Division of Oil, Gas and Mining

Inspection Report

Permit Number:	C0250005
Inspection Type:	TECHNICAL
Inspection Date:	Monday, September 29, 2014
Start Date/Time:	9/29/2014 2:00:00 PM
End Date/Time:	9/30/2014 12:30:00 PM
Last Inspection:	Tuesday, September 09, 2014

Site: **COAL HOLLOW**

Above: Pit 10. Below: Kirk Nichols addresses Cheryl Parker, Lisa Reinhart, Joe Helfrich, Steve Christensen, Amanda Daniels, and Keenan Storer

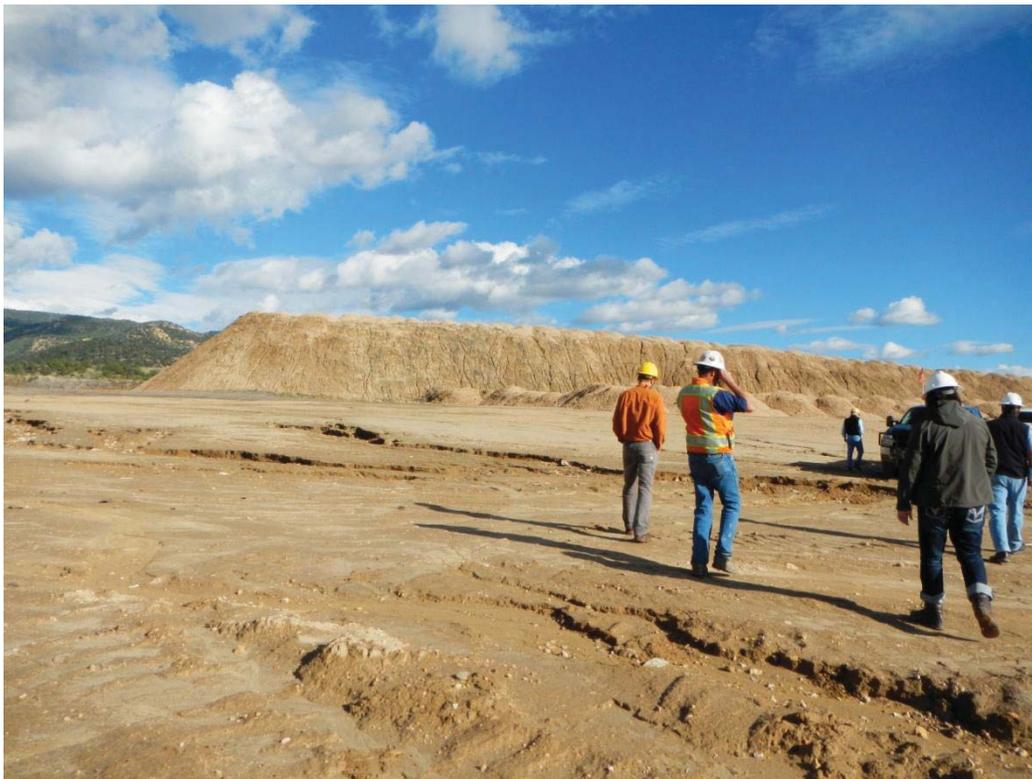
The coal seam was exposed in Pit 10 which has been opened on about one quarter of its length. Pit 10 may be the location of the proposed underground portals. The highwall in pit 10 is benched every 40 feet (two benches) and the alluvium height is approximately 30 ft. for a total of 110 ft. of cover. The 40 ft highwall above the portals would be shot-creted to prevent sloughing of the shale.

The underground mining proposal is under review as Task 4652. The coal seam was exposed in Pit 10 which has been opened on about one quarter of its length. The access to Pit 10 is through Pit 9. Pit 10 may be the location of the proposed underground portals, although the application describes the location as Pit 11. The highwall in pit 10 is benched every 40 feet (two benches) and the alluvium height is approximately 30 ft., for a total of 110 ft cover at this location. The proposed configuration of the underground access is shown on Dwg 5-3B of Task 4652, under review. The 40 ft highwall above the portals would be shot-creted to prevent sloughing of the shale. Pit 10 is flooded with water coming from the alluvium. The alluvial water management plan described in the MRP had not been instituted for this pit.
